STATE OF CONNECTICUT  
CONNECTICUT SITING COUNCIL

APPLICATION OF NEW CINGULAR WIRELESS PCS,  
LLC (AT&T) FOR A CERTIFICATE OF  
ENVIRONMENTAL COMPATIBILITY AND PUBLIC  
NEED FOR THE CONSTRUCTION, MAINTENANCE  
AND OPERATION OF A TELECOMMUNICATIONS  
TOWER FACILITY LOCATED AT THE FIRSTLIGHT  
HYDRO GENERATING COMPANY PROPERTY AT  
KENT ROAD IN THE TOWN OF NEW MILFORD,  
CONNECTICUT

DOCKET NO. 444

NEW CINGULAR WIRELESS, PCS LLC (AT&T) RESPONSES TO CONNECTICUT  
SITING COUNCIL PRE-HEARING QUESTIONS SET II

**AT&T Proposed Coverage (1900 MHz) with S4067 at New Milford, CT @ 146' AGL**

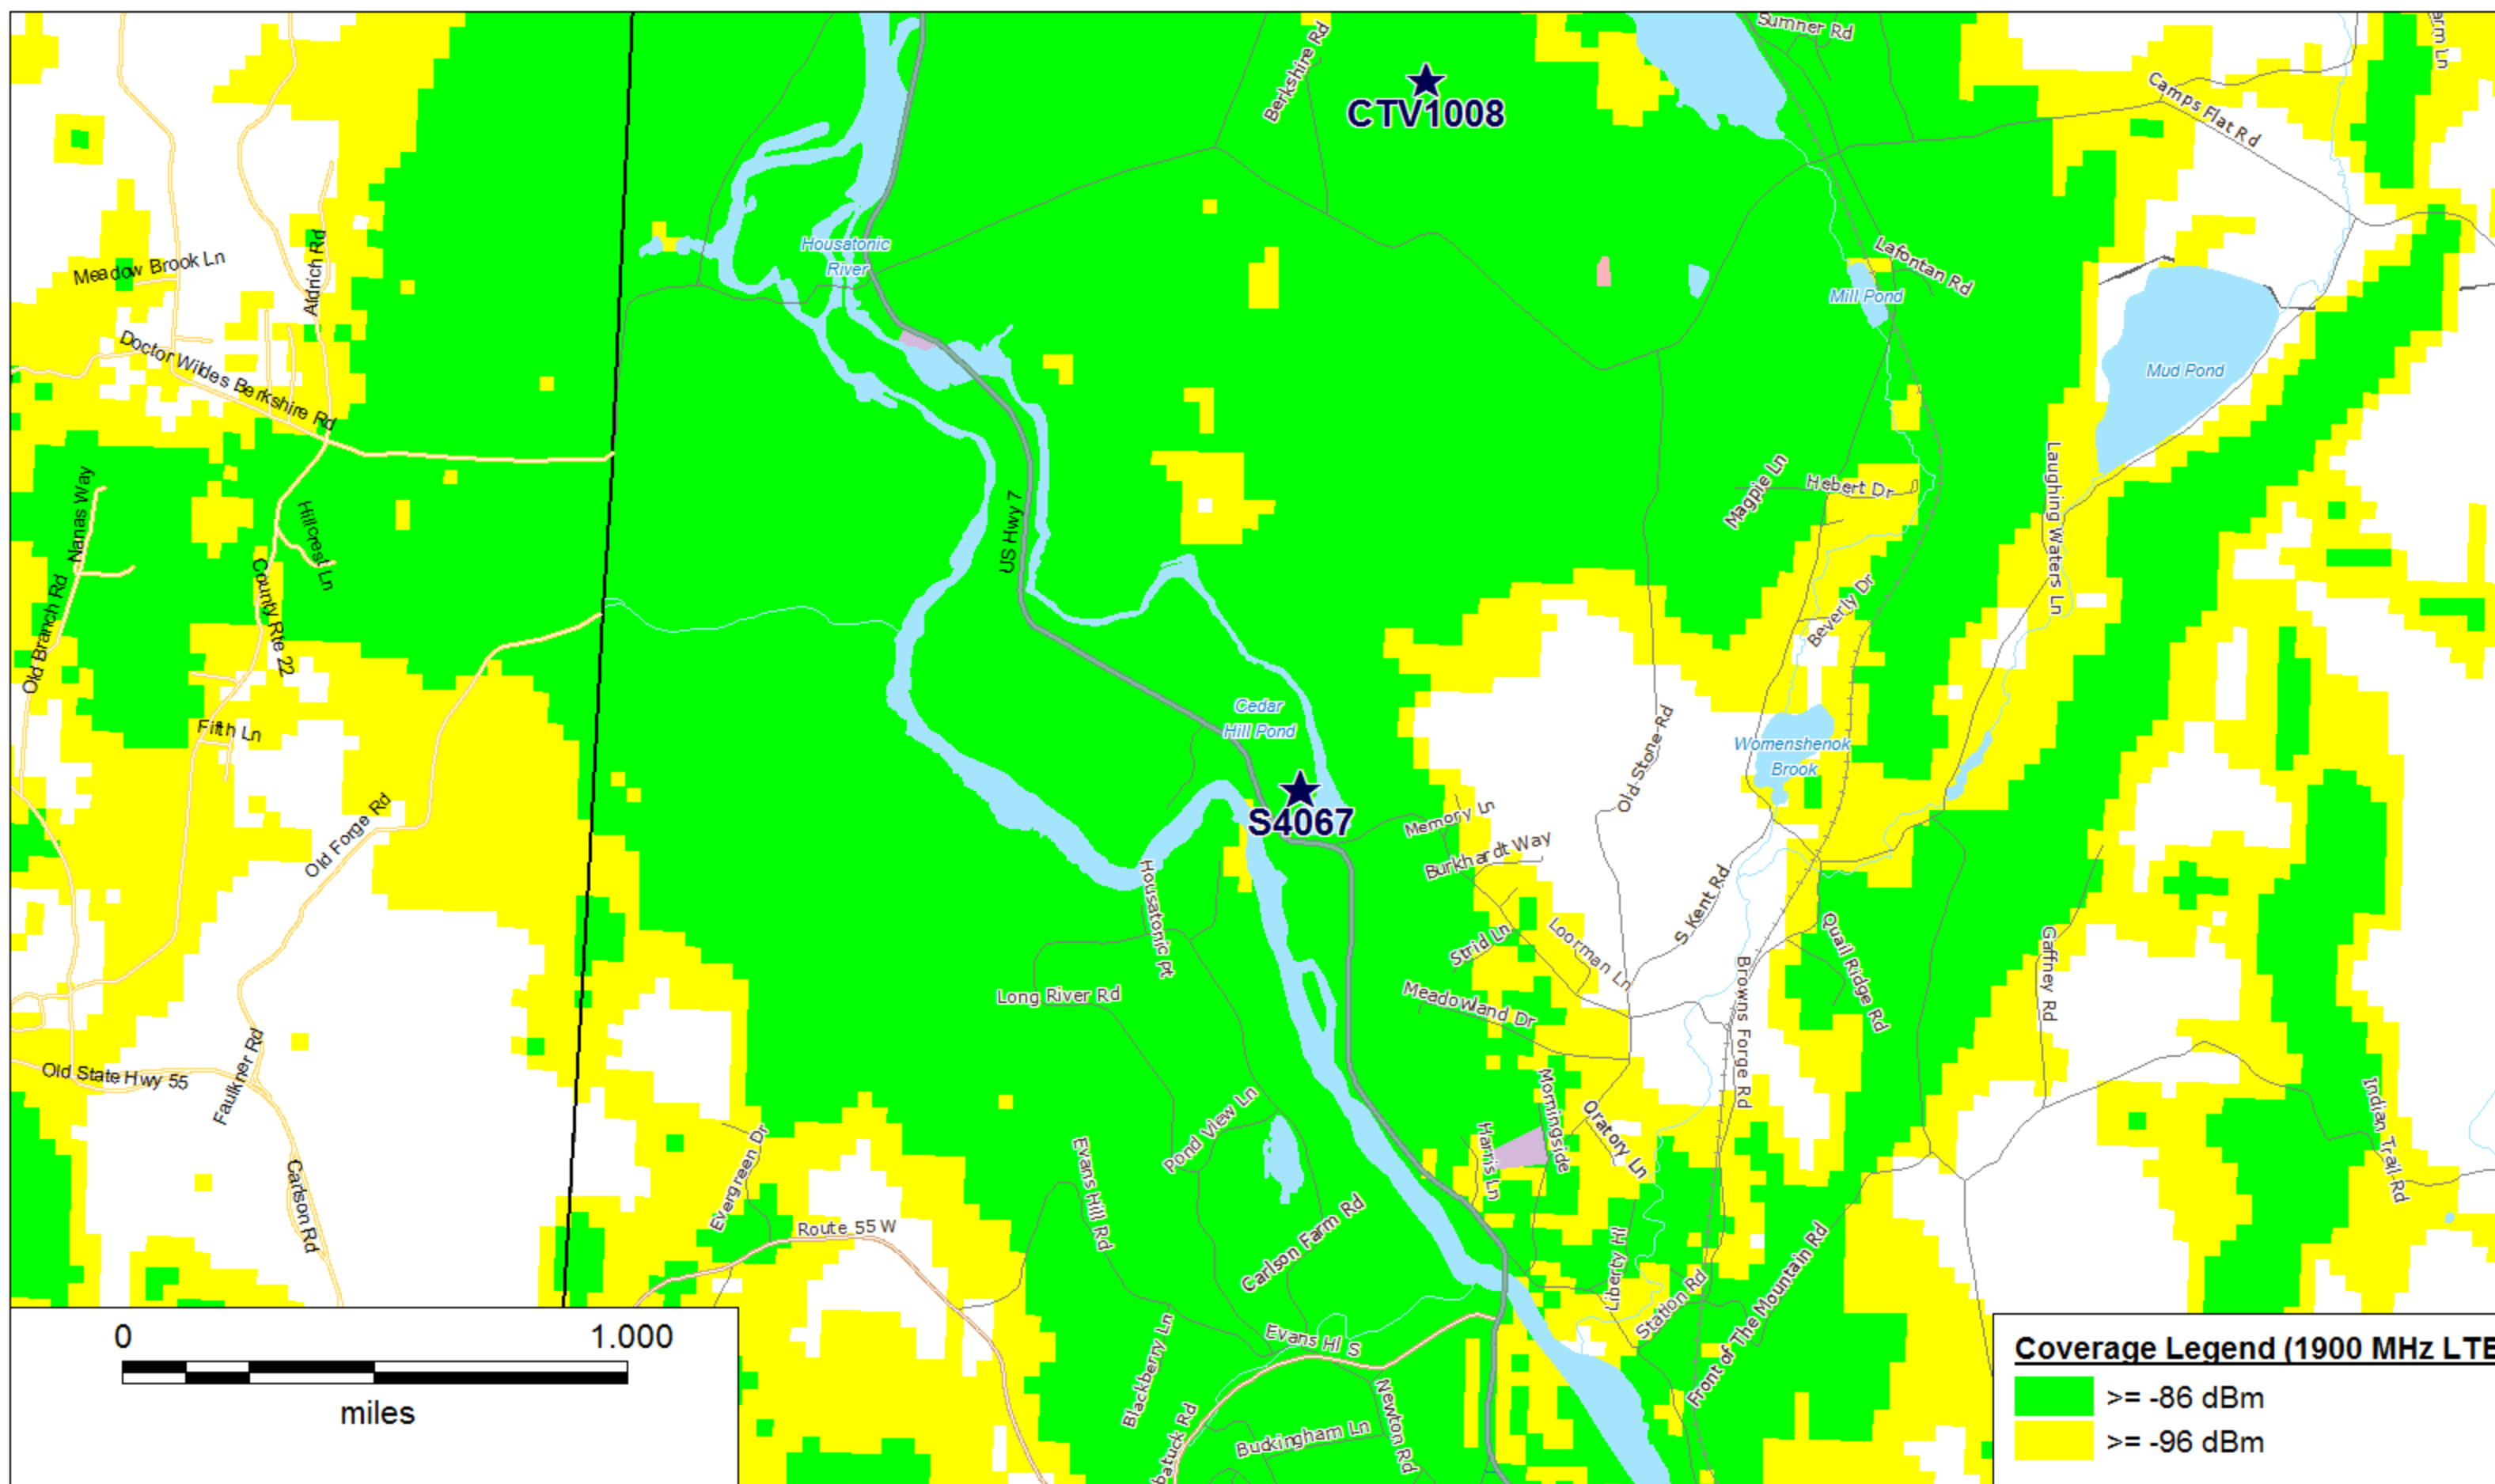
Q48. Using the same scale as the previous coverage plots, provide existing coverage plots for LTE and PCS. Also include LTE and PCS coverage plots depicting the existing and proposed coverage.

A48. Please see the coverage plots included in Attachment 1.
